GARVEY COMMONS/ SHERBURNE HALL ADDITIONS & REMODELING
ST. CLOUD STATE UNIVERSITY
ST. CLOUD MINNESOTA

Sheet S-1

ADDENDUM #2, 17 JANUARY 1987, PROJECT 86015
 WAYNE C. LARSON
 STRUCTURAL ENGINEERS
 2129 2ND STREET
 WHITE BEAR, MN 55110
 612/429-8363

FOUNDATION and FIRST FLOOR PLAN

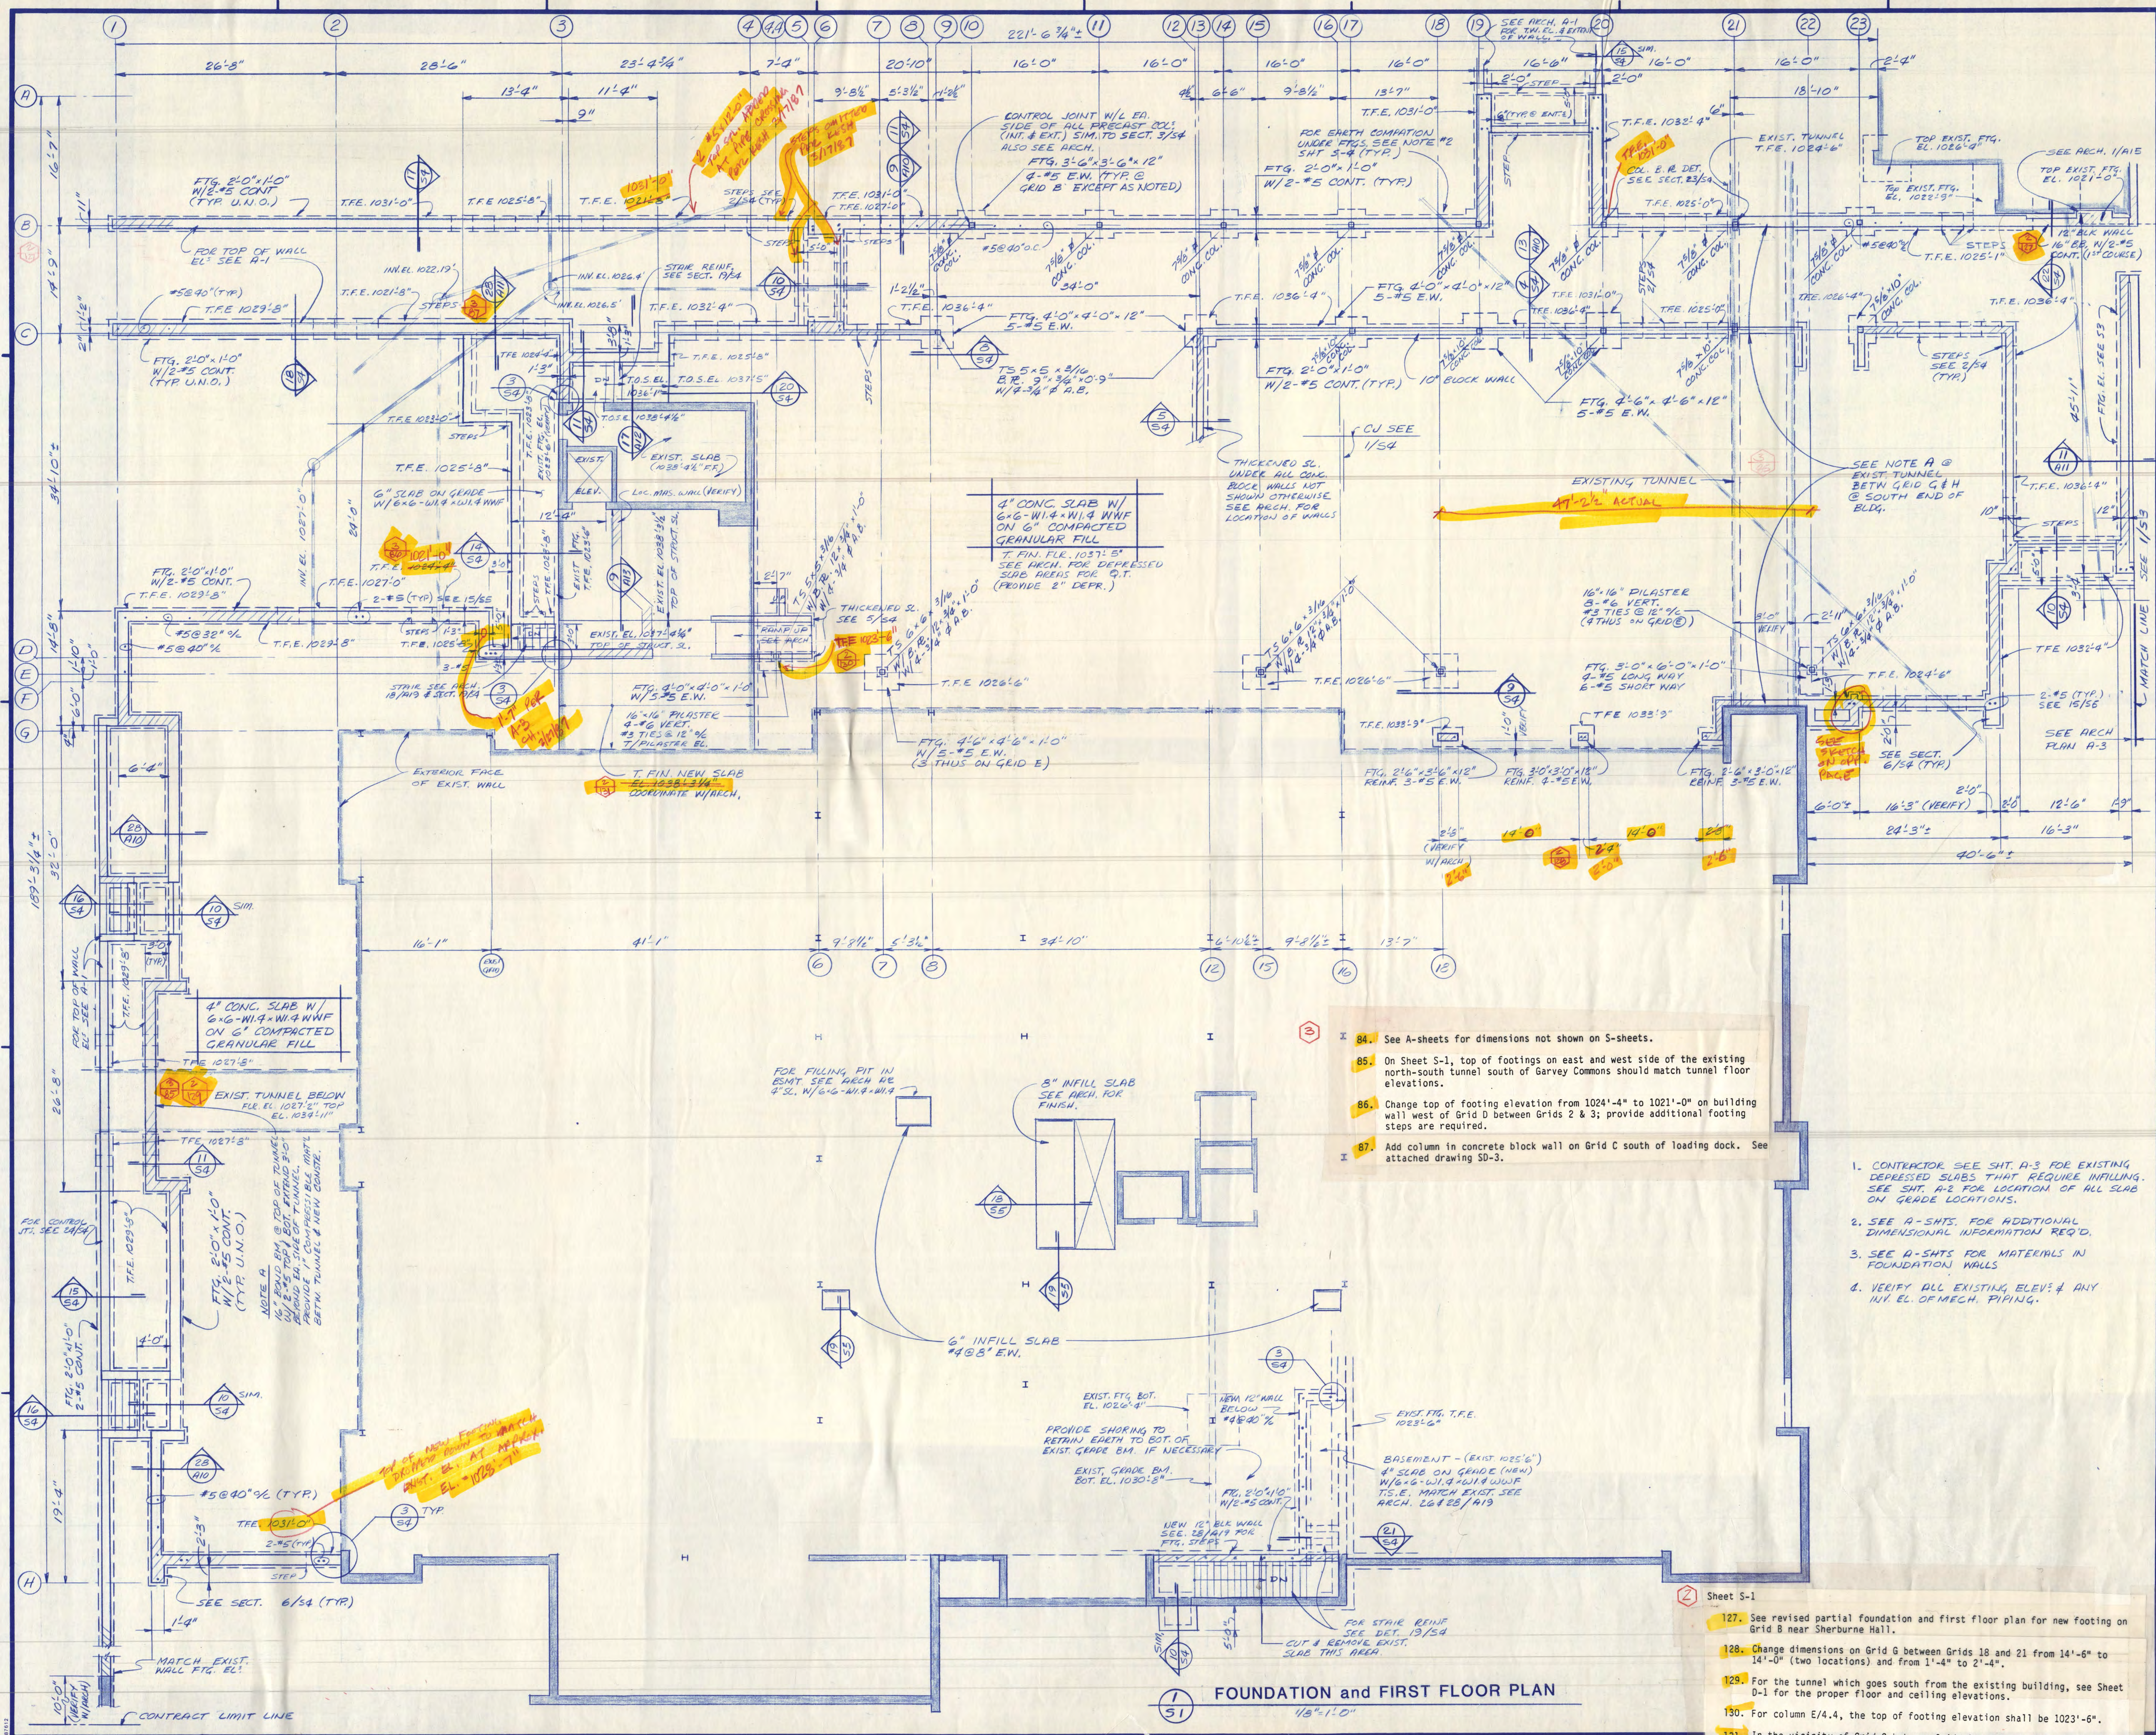
- 84. See A-sheets for dimensions not shown on S-sheets.
- 85. On Sheet S-1, top of footings on east and west side of the existing north-south tunnel south of Garvey Commons should match tunnel floor elevations.
- 86. Change top of footing elevation from 1024'-4" to 1021'-0" on building wall west of Grid D between Grids 2 & 3; provide additional footing steps as required.
- 87. Add column in concrete block wall on Grid C south of loading dock. See attached drawing SD-3.

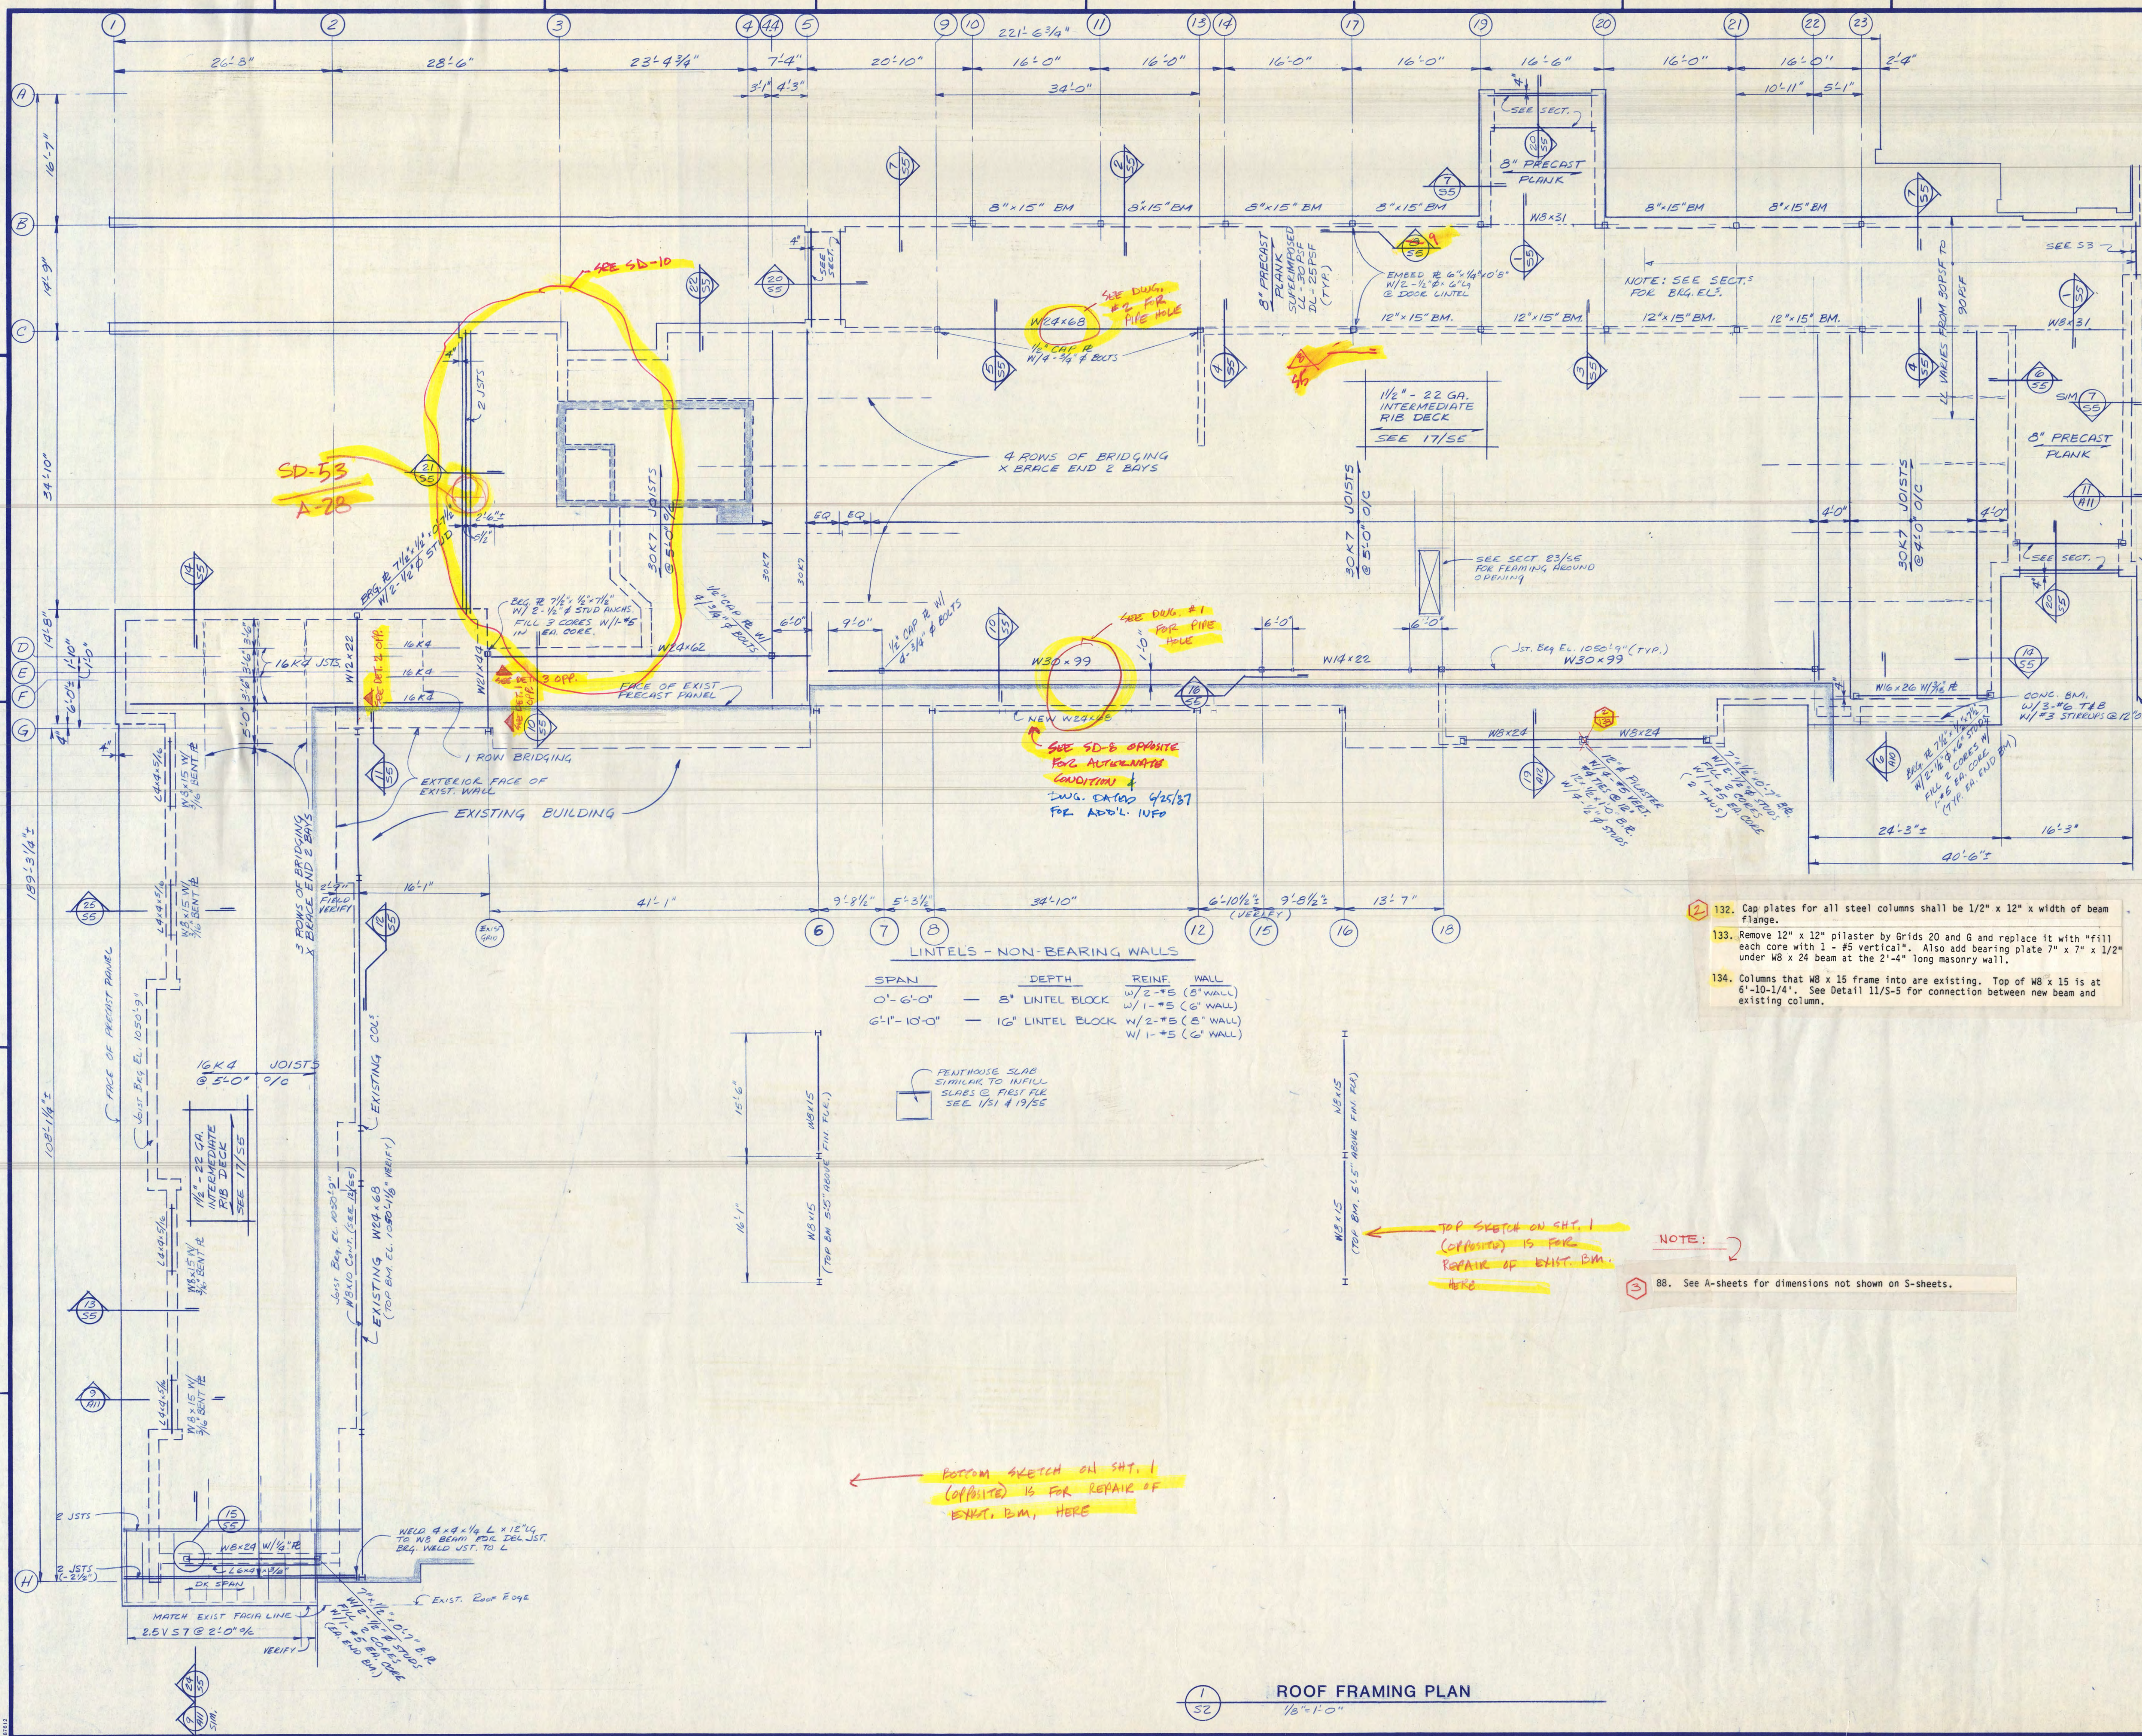
127. See revised partial foundation and first floor plan for new footing on Grid B near Sherburne Hall.

128. Change dimensions on Grid G between Grids 18 and 21 from 14'-6" to 14'-0" (two locations) and from 1'-4" to 2'-4".

129. For the tunnel which goes south from the existing building, see Sheet D-1 for the proper floor and ceiling elevations.

130. For column E/4.4, the top of footing elevation shall be 1023'-6".

131. In the vicinity of Grid G between Grids 3 and 4, delete the elevation of 1038'-3-1/4" as the top finish new slab; see Sheet A-3 for correct elevations.

1
ROOF FRAMING PLAN
1/8"=1'-0"

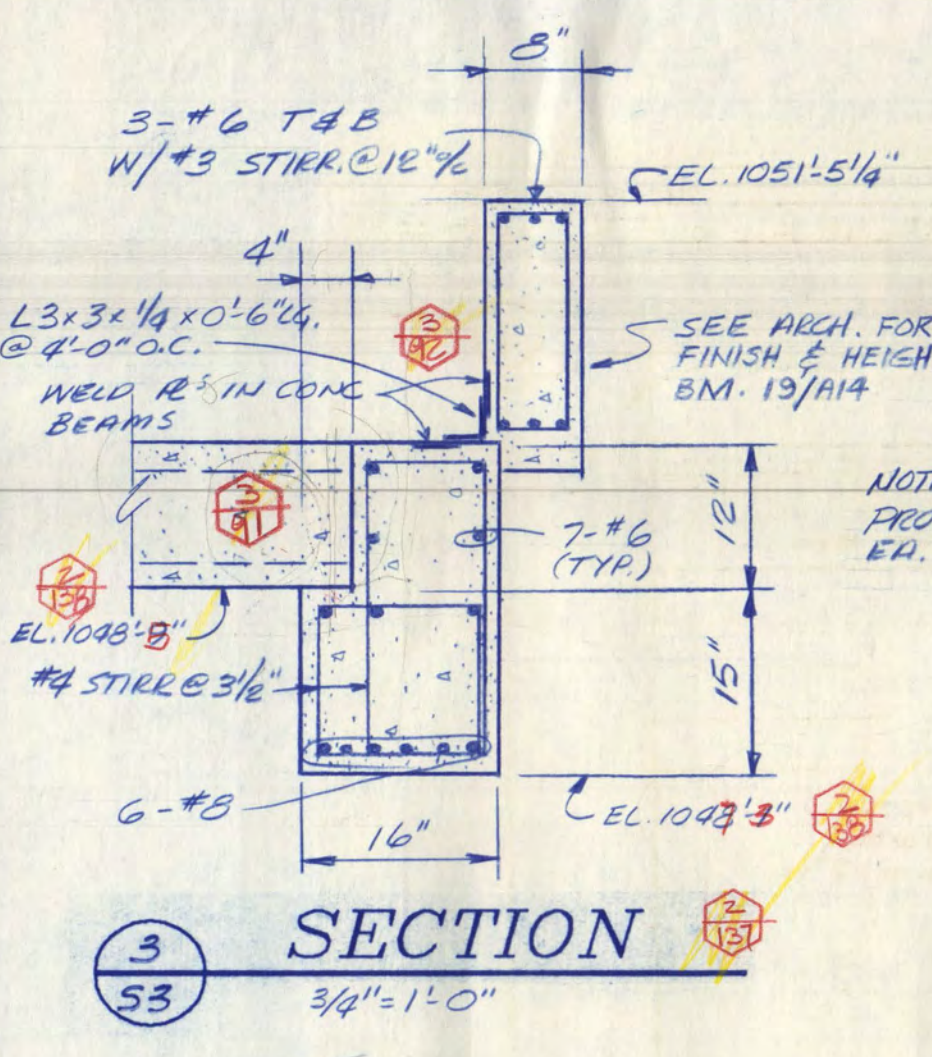
- 132. Cap plates for all steel columns shall be 1/2" x 12" x width of beam flange.
- 133. Remove 12" x 12" pilaster by Grids 20 and G and replace it with "fill" each core with 1-#5 vertical". Also add bearing plate 7" x 7" x 1/2" under W8 x 24 beam at the 2'-4" long masonry wall.
- 134. Columns that W8 x 15 frame into are existing. Top of W8 x 15 is at 6'-10-1/4". See Detail 11/S-5 for connection between new beam and existing column.
